Block 16 Section 10

From last NCDRP session...

Respond to urban form

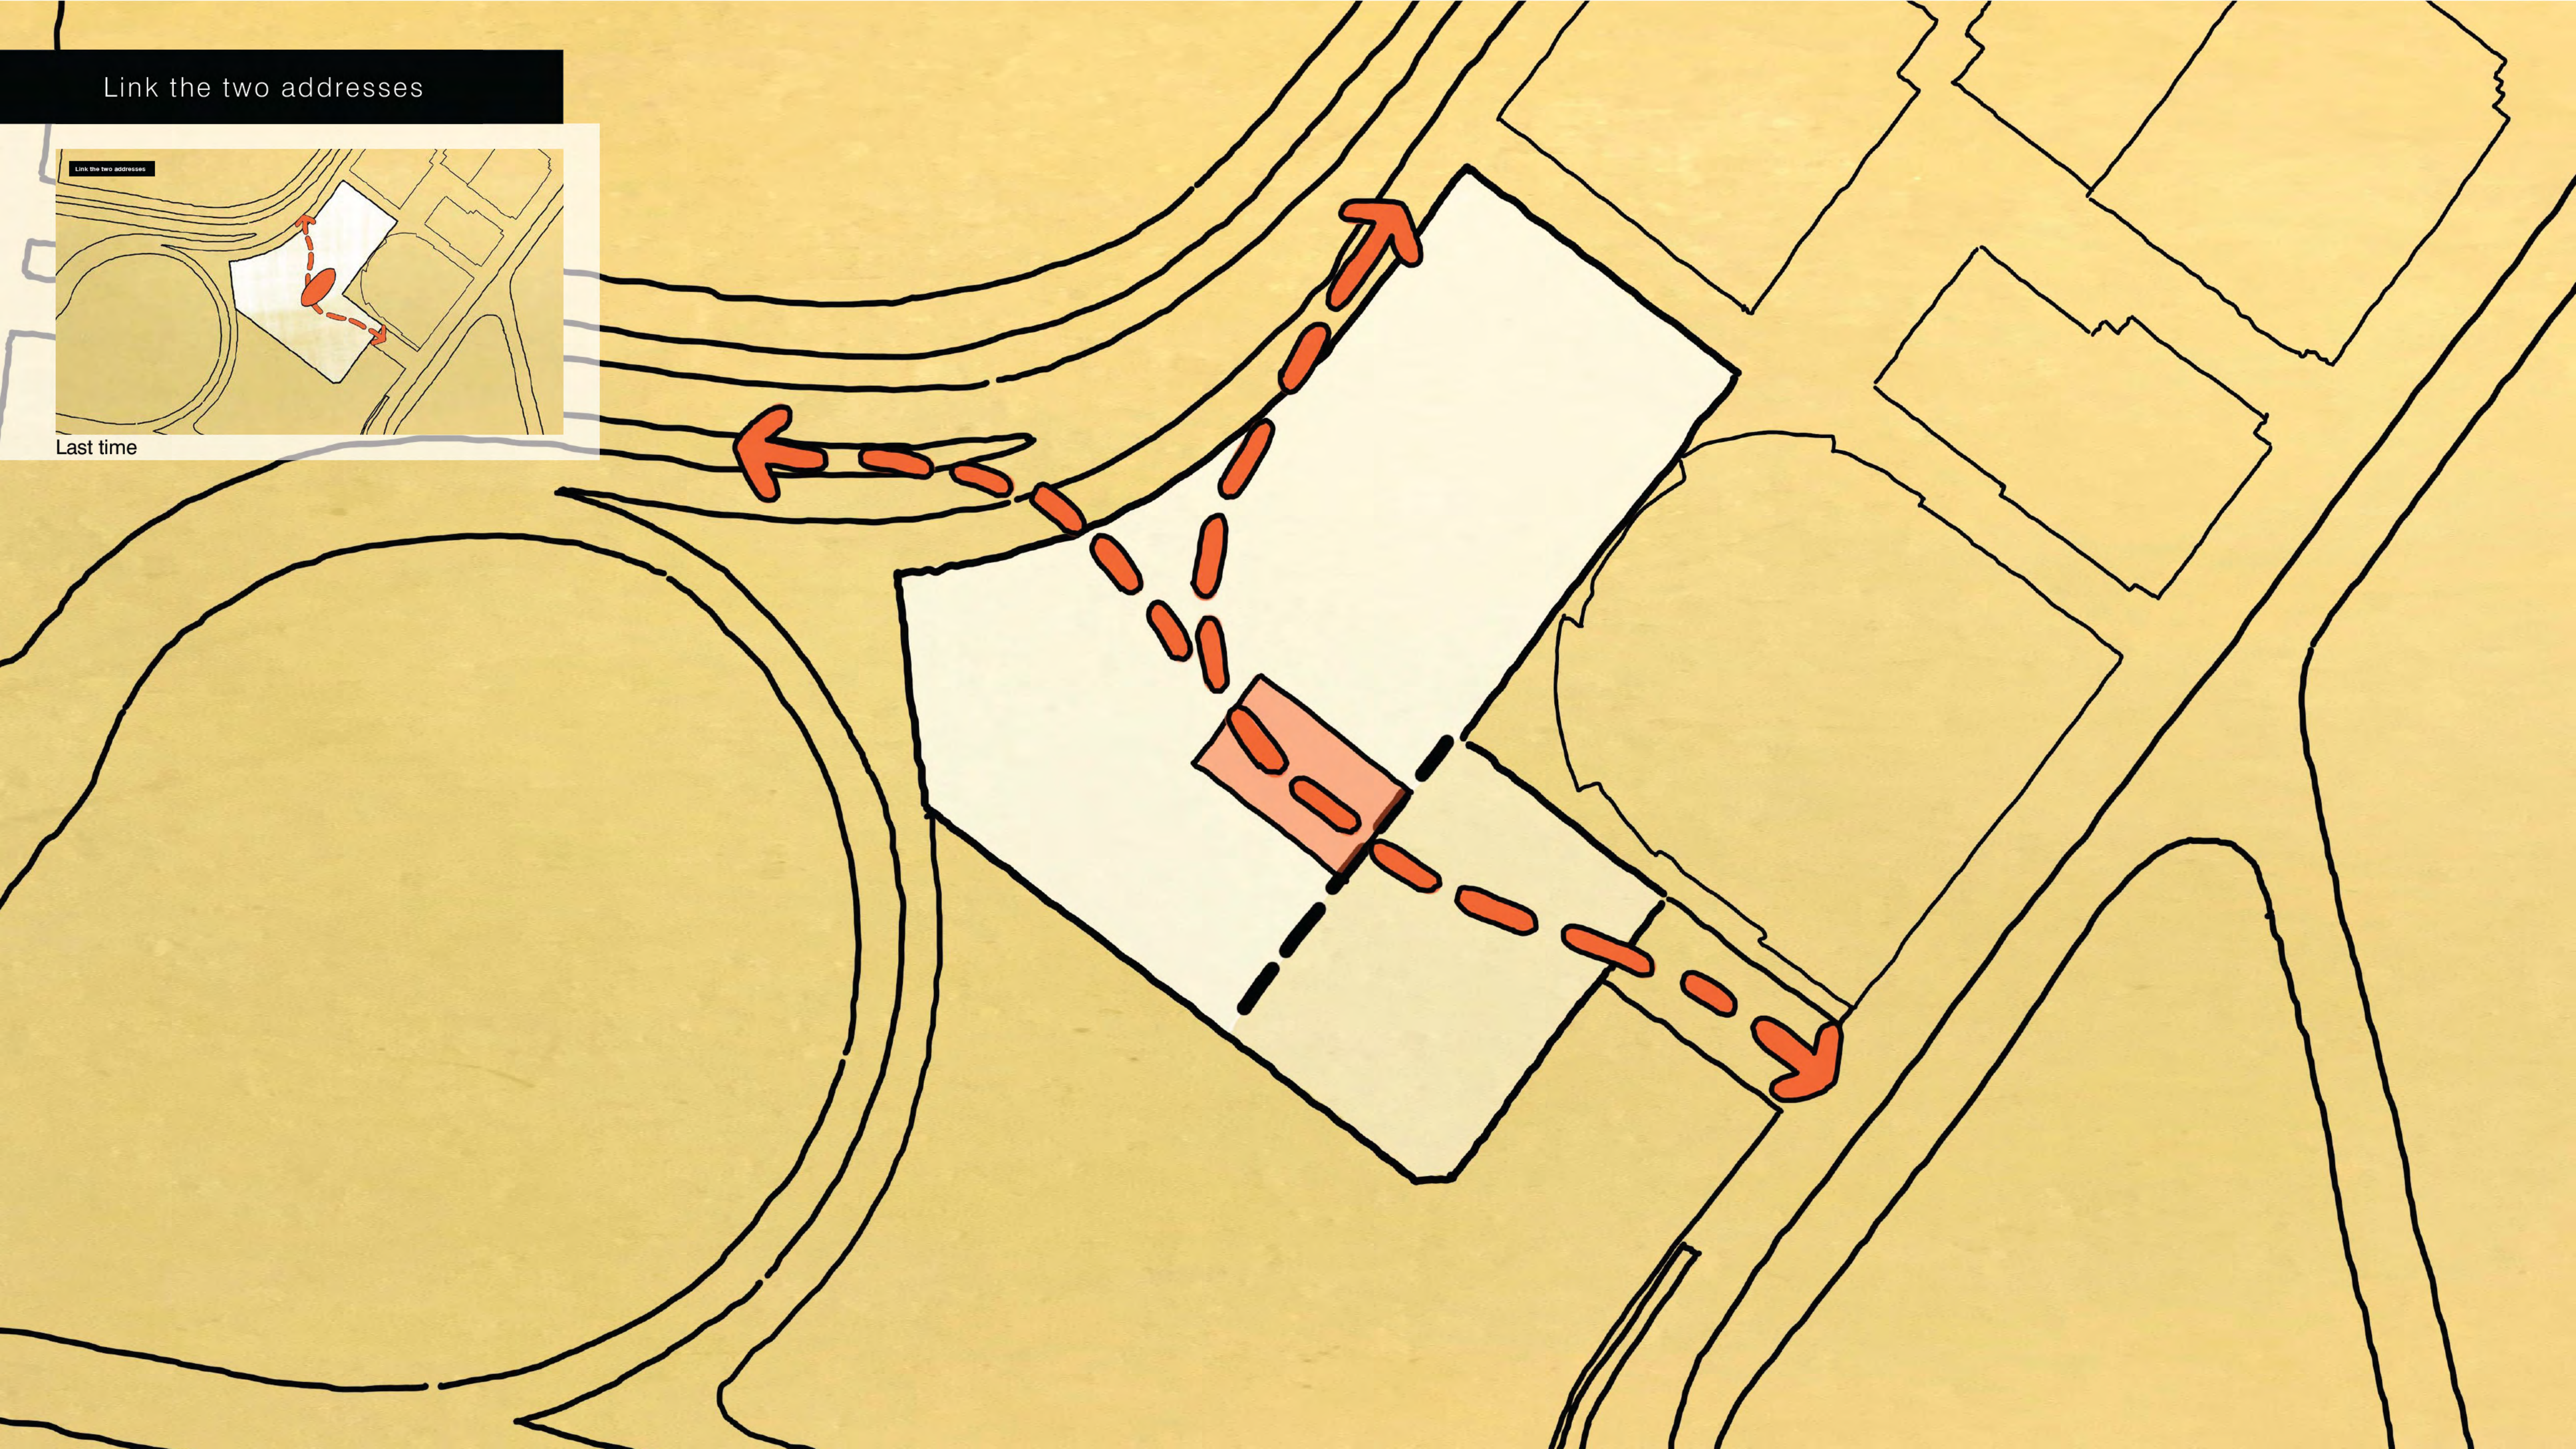
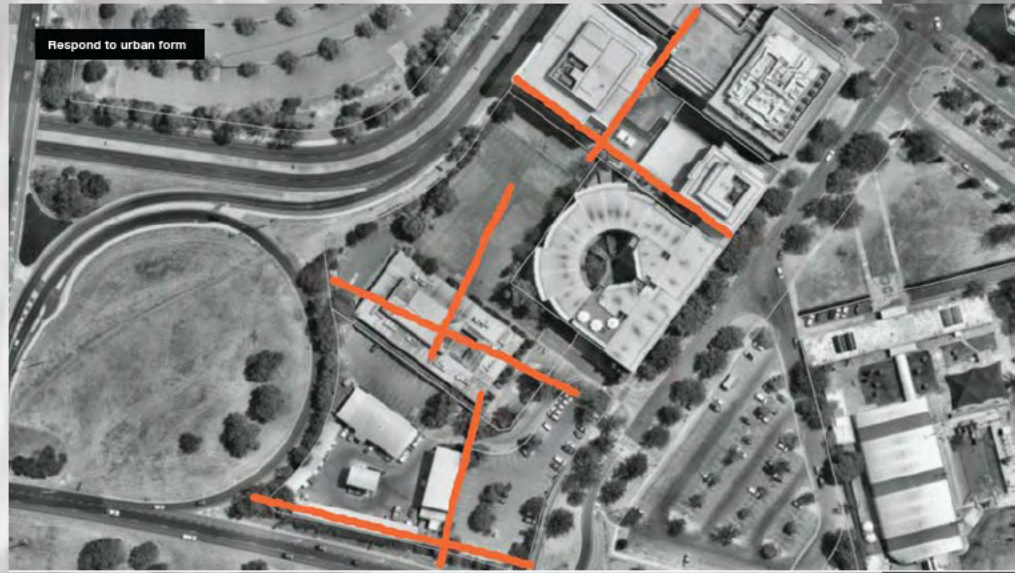
DRP ADVICE 1.2

The proposed alignment of the residential and commercial buildings is not supported by the Panel as it is considered to lack the required formal response in its address to London Circuit or provide an appropriate civic response commensurate with the prestigious site location in the National Triangle. Acknowledging the proponent's intent for the commercial component of the proposal to align with London Circuit and the adjacent DFAT building, the Panel considers that the scale and fragmented nature of this offering does not provide a satisfactory civic response in its geometry or scale. Furthermore, the Panel is unconvinced that the alignment of the proposed residential buildings to Parkes Way is justified, noting that the form and scale of the residential buildings are considered by the Panel to dominate the proposal. The proponent is therefore encouraged by the Panel to return to 'first principles' including reconsideration of their understanding of the site context and planning principles. Additionally, the Panel strongly recommends that the proposal should more formally address and align to the London Circuit geometry through greater consideration for axis' in Griffin's plan. The Panel recommends that this be demonstrated by presenting options at the next design review session. (See also 5.0 and 6.0)

The alignment of the proposed buildings match that of London Circuit
